**GOVERNMENT OF THE DISTRICT OF COLUMBIA
DEPARTMENT OF CONSUMER AND REGULATORY AFFAIRS
OFFICE OF THE ZONING ADMINISTRATOR**

RE: 911 Evarts Street, NE
Lot 13, Square 3843
Zone C-2-C

A4.01

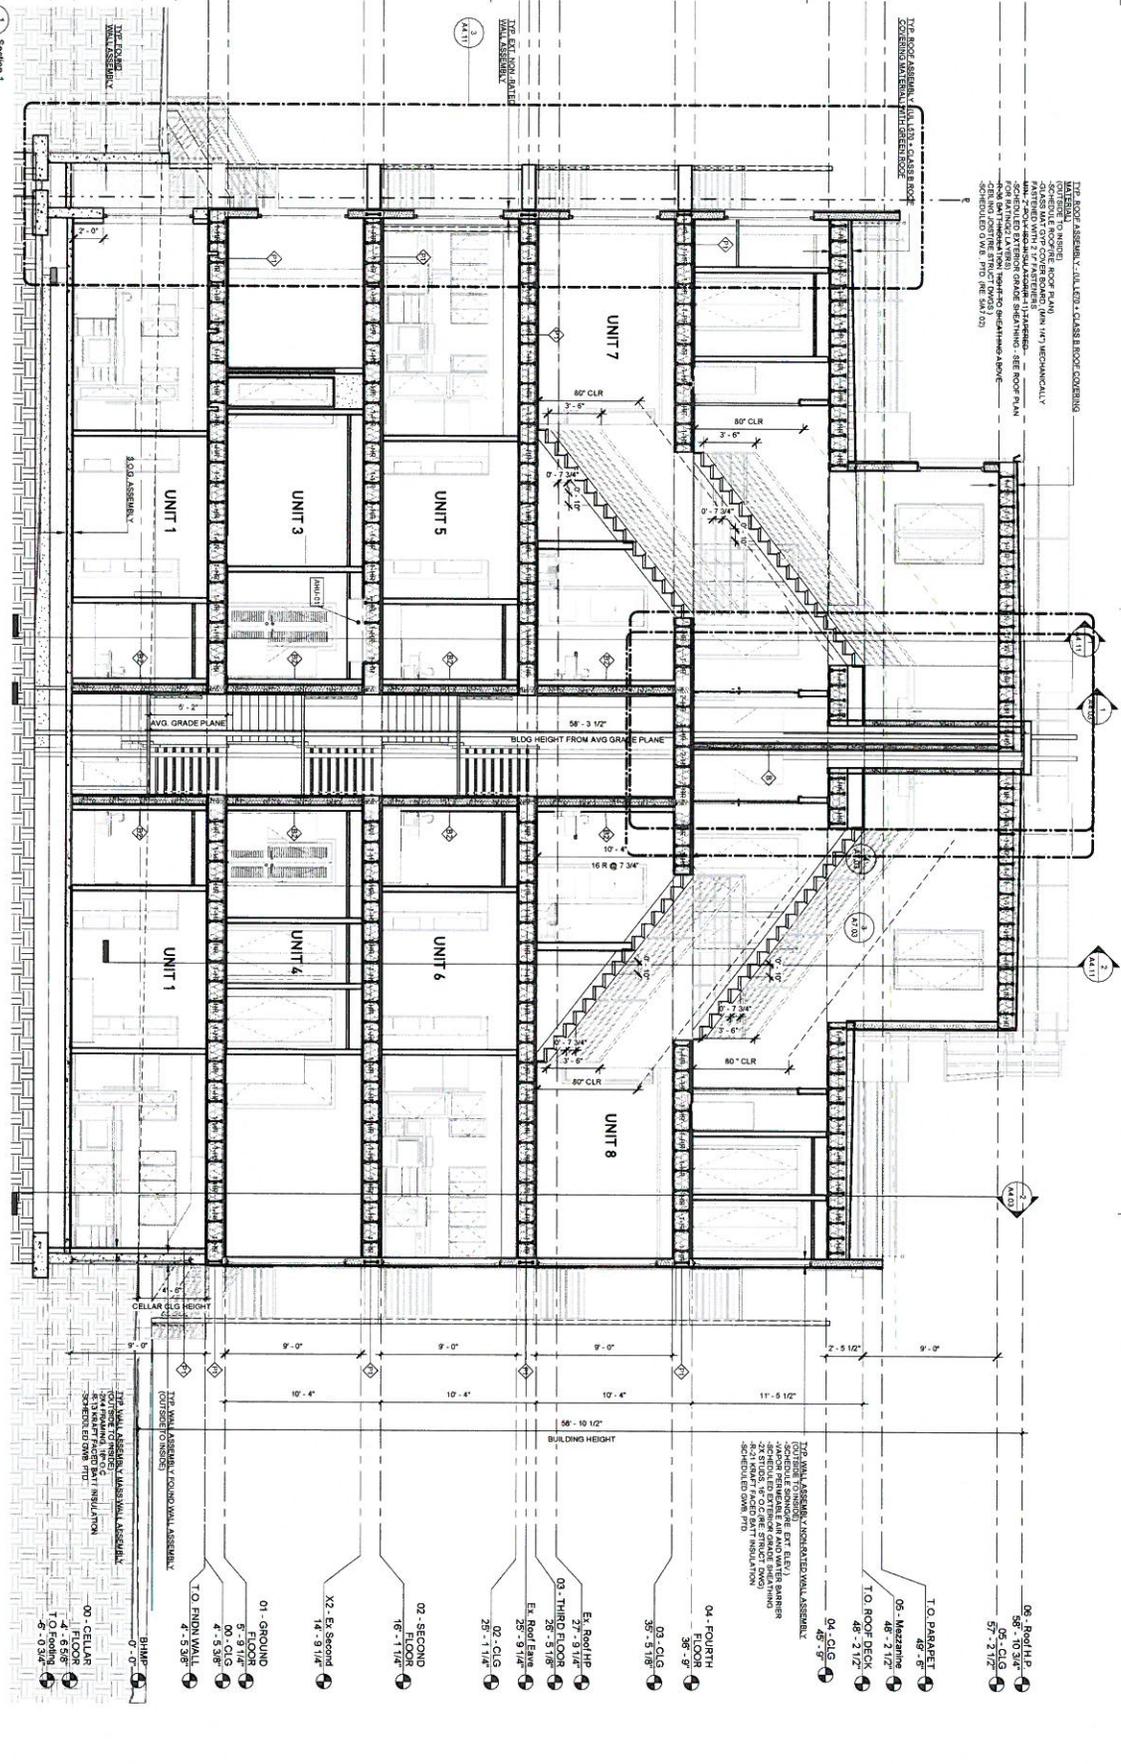
1. Height / Number of Stories. The height of proposed building is 58'-10 ³/₄', which is in conformance with 11 DCMR 770.1. The height is measured from the top of the street curb opposite the middle of the front of the building to the height point of the roof. The distance between the Building Height Measuring Point (BHMP) and the finished cellar ceiling is 2'-8 ¹/₂"; therefore the lowest level is considered a cellar. The proposed Project consists of a four-story building with mezzanine and cellar, which is in conformance with 11 DCMR 770.1.

2. Addition / Alteration. The proposed Project shall be considered an alteration and addition of the existing apartment house as approximately 63% of the exterior envelope is being retained. A portion of the front wall, the rear wall and roof (1,342 sf) will be removed and the remainder of the front wall and party walls will remain (2,250 sf).

3. Floor Area Ratio. The site is 1,690 sf and the proposed gross floor area is 5,004. The proposed floor area ratio (FAR) is 2.96, and is thus in conformance with 11 DCMR 771.2 which states the maximum residential FAR for the C-2-C zone is 6.0 (10,140 sf).

4. Lot Occupancy. The proposed project occupies 1,222 sf (72%) of the existing lot and is thus in conformance with 11 DCMR 772.1 which states that the maximum lot occupancy in the C-2-C zone is 80%. The main entrance stair at the front of the building serves the ground floor / principal entrance and is not counted towards the lot occupancy.

5. Rear Yard. The proposed rear yard between the rear of the building and the rear property line measures 19.3' and is thus in conformance with 11 DCMR 774.1 which state the minimum rear yard in the C-2-C zone is 15'.

8. Parapet / Penthouses. The proposed parapet is 3'-6" above the roof highpoint and is in compliance with the recently changed penthouse regulations 11 DCMR 411.3. There is no proposed penthouse.

9. Areaways. The proposed Project will include an areaway at the front that measures three (3) feet from the building to the face of retaining wall. A second areaway is located at the rear and measures three feet, two inches (3'-2") from the building to the face of the retaining wall. As I have previously indicated, window wells (no pedestrian access and no more than 4' in width) and areaways (pedestrian access and no more than 5' in width) are permitted and do not affect the building height or gross floor area calculation.

10. Court Niches. The proposed Project will include rear balconies that measures nine foot nine inches (9'-9") wide and projects three foot ten inches (3'-10"). As the site is eighteen feet (18') wide, there are two court niches on either side of the balcony are formed. The first court niche measures three foot one inches (3'-1") wide by three foot ten inches (3'-10") deep. The second court niche measures five foot two inches (5'-2") wide by three foot ten inches (3'-10") deep. Also, as per the definition of Gross Floor Area, outside balconies that project less than six feet from the building are not included as per 11 DCMR 11-199.

Accordingly, when you file the plans for a building permit, I will approve drawings that are consistent with the information noted above. Please let me know if you have any further questions.
